TRANS/WP.29/2004/6
16 December 2003

PROPOSAL FOR DRAFT SUPPLEMENT 4 TO REGULATION No. 65

(Special warning lamps)

Transmitted by the Working Party on Lighting and Light-Signalling (GRE)

Item 2, amend to read:

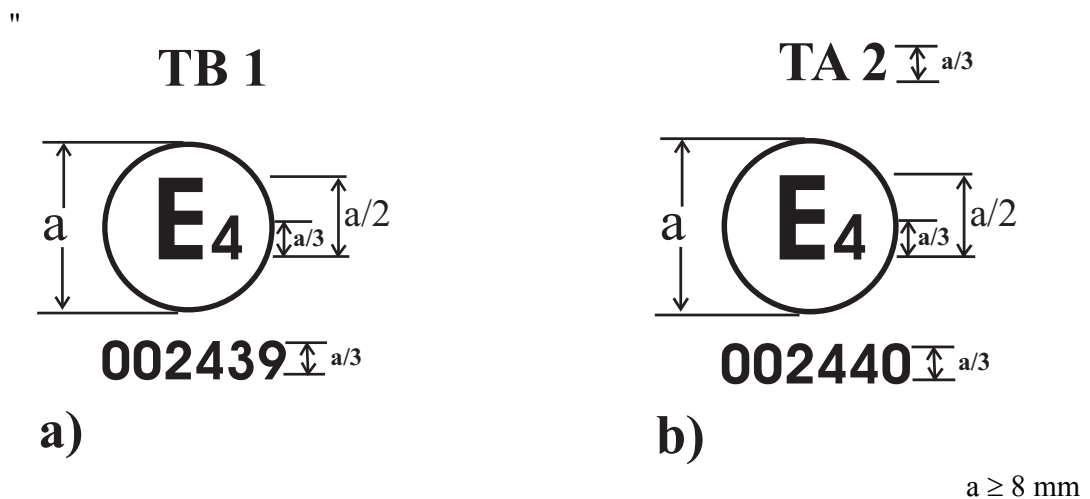
- "2. Special warning lamp has one/ two levels of intensity 2/
Special warning lamp consists of separate units."

Examples of approval marks, amend to read:

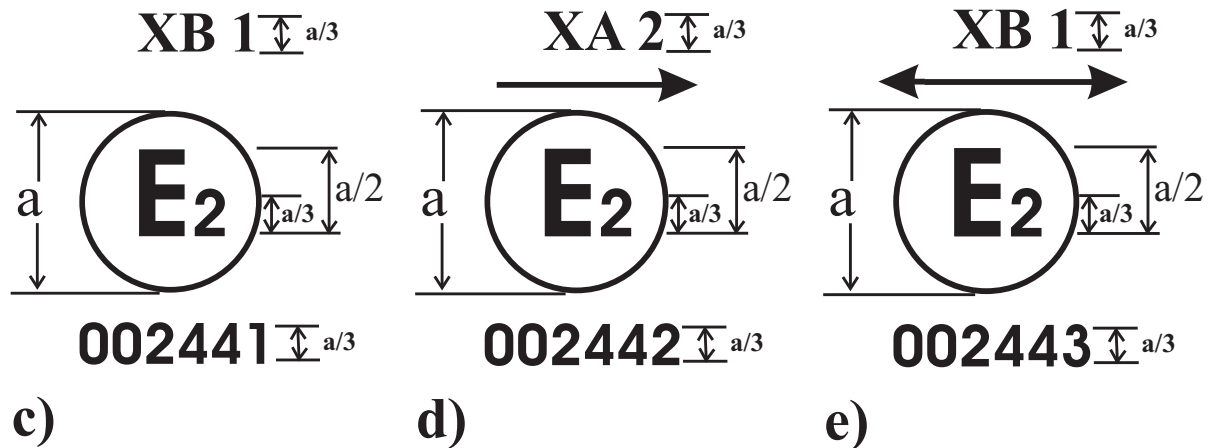
- a) a special warning lamp indicates that it has been approved in the Netherlands (E4) under approval number 002439. The approval number shows that the approval was granted in accordance with the requirements of the Regulation in its original form and that it is a blue rotating or stationary flashing special warning lamp of class 1 (TB 1).
- b) a directional flashing lamp indicates that it has been approved in the Netherlands (E4) under approval number 002440. The approval number shows that the approval was granted in accordance with the requirements of the Regulation in its original form and that it is a amber rotating or stationary flashing special warning lamp of class 2 (TA 2)."

- c) a directional flashing lamp indicates that it has been approved in France (E2) under approval number 002441. The approval number shows that the approval was granted in accordance with the requirements of the Regulation in its original form and that it is a blue directional flashing lamp of class 1 (XB 1).

The marking without an arrow indicates that the lamp has a narrow-angle effect.

- d) a directional flashing lamp indicates that it has been approved in France (E2) under approval number 002442. The approval number shows that the approval was granted in accordance with the requirements of the Regulation in its original form and that it is a amber directional flashing lamp of class 2 (XA 2).

The arrow indicates that the lamp has a wide-angle effect on the side indicated by the direction in which the arrow is pointing, which also indicates the side of the vehicle on which the device is to be mounted.

- e) a directional flashing lamp indicates that it has been approved in France (E2) under approval number 002443. The approval number shows that the approval was granted in accordance with the requirements of the Regulation in its original form and that it is a blue directional flashing lamp of class 1 (XB 1).

The double side arrow indicates that the lamp has a wide-angle effect to both sides, which also indicates that the lamp could be mounted on both side of the vehicle.

7.3.1. Table of standard light distribution for special warning flash lamp (Category X)

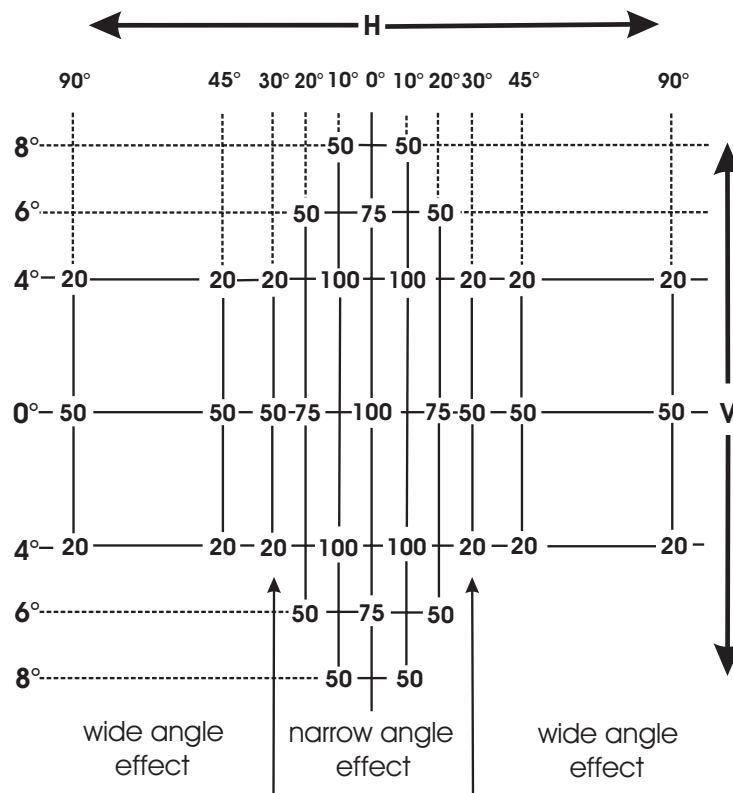
Minimum horizontal angular range of category "narrow angle effect" is 30° left to 30° right and for category "wide angle effect" 90° directed outwards the vehicle and 30° to the inside.

- 7.3.1.1. The direction $H = 0^\circ$ and $V = 0^\circ$ corresponds to the reference axis. (On the vehicle it is horizontal, parallel to the median longitudinal plane of the vehicle and oriented in the required direction of visibility). It passes through the centre of reference. The values shown in the table give, for the various directions of measurements, the minimum intensities as a percentage of the minimum required in the axis for each lamp (in the direction $H = 0^\circ$ and $V = 0^\circ$).
- 7.3.1.2. Within the field of light distribution of paragraph 7.3.1. schematically shown as a grid, the light pattern should be substantially uniform, i.e. the light intensity in each direction of lowest minimum value being shown on the grid lines surrounding the questioned direction as a percentage."
